SERVICE LETTER

No. 790

Piper Aircraft Corporation

Paralleling Relay Terminal Strip Tab
Modification.

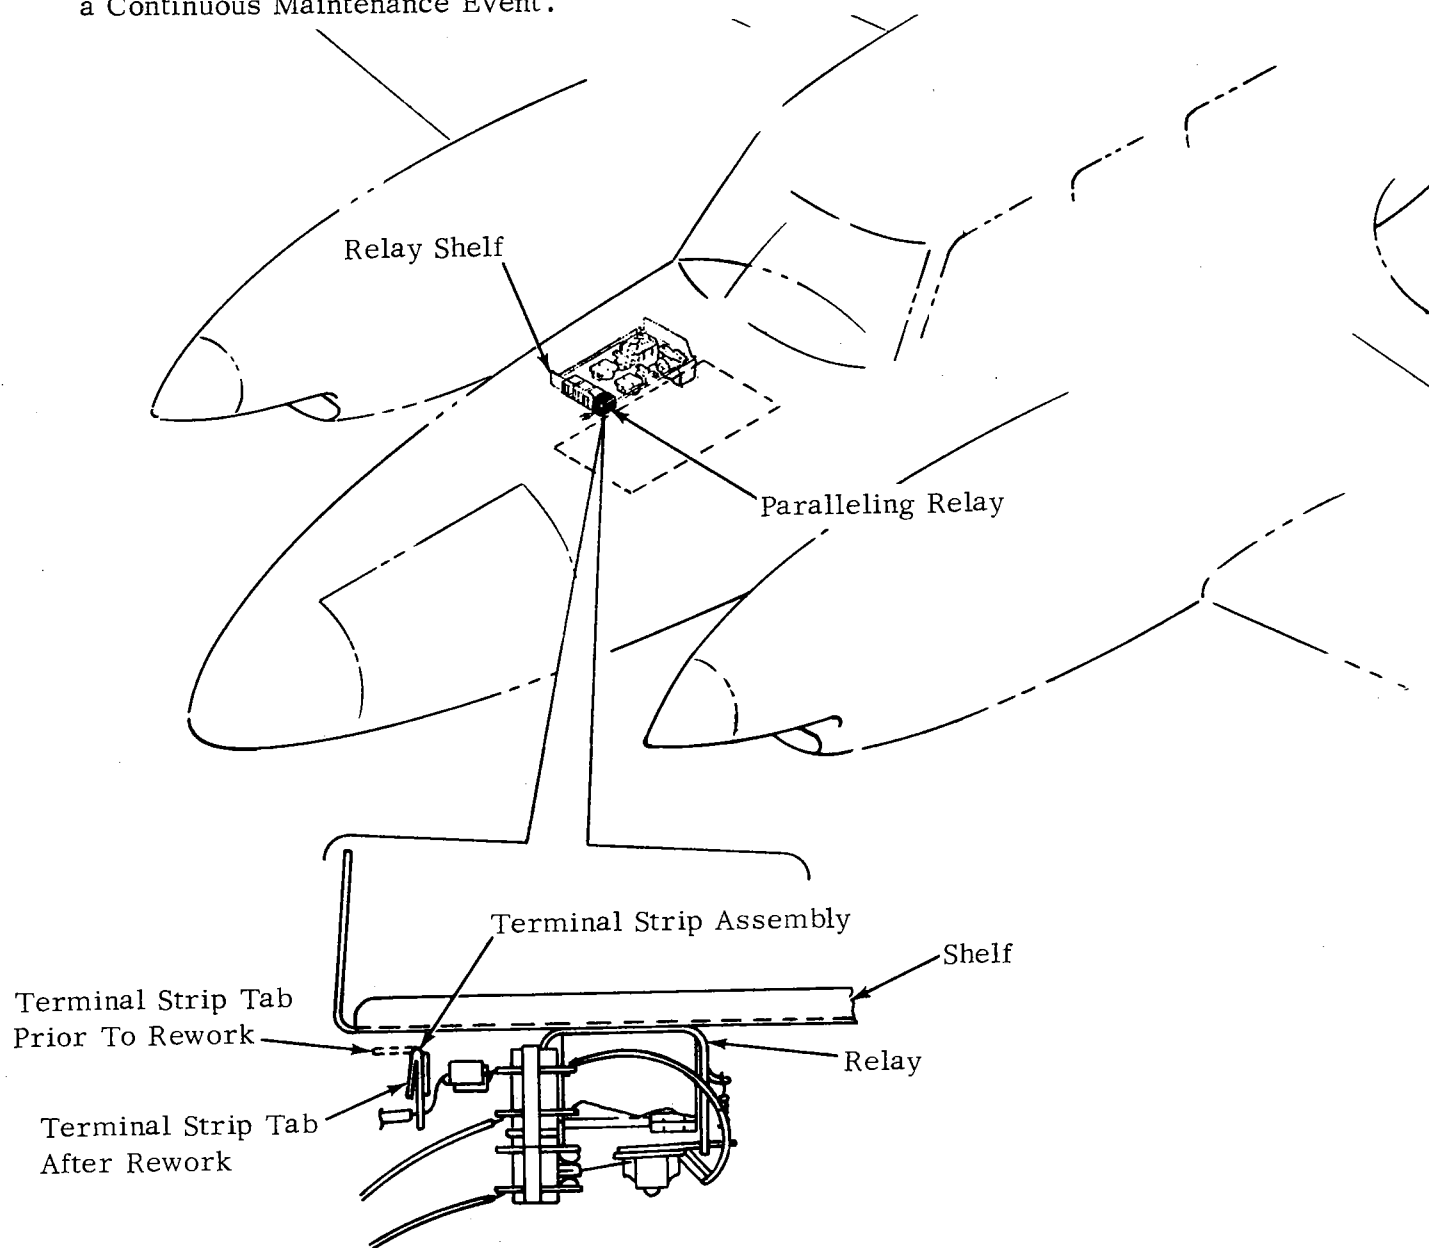
During routine factory systems testing, it has come to our attention that, by turning the generator bus tie switch "OFF" a short can occur at the paralleling relay terminal strip tab if the tab contacts the adjacent paralleling relay supporting shelf.

1. Gain access to relay shelf by removing access panel from right side of fuselage nose section.
2. Remove Royalite cover from relay shelf.
3. Locate paralleling relay and rework terminal strip by bending tab down from shelf as shown. Wrap electrical tape around complete terminal strip after tab is bent down from shelf.
4. Reinstall Royalite cover and fuselage access panel.
5. Make proper Logbook entry of modification.
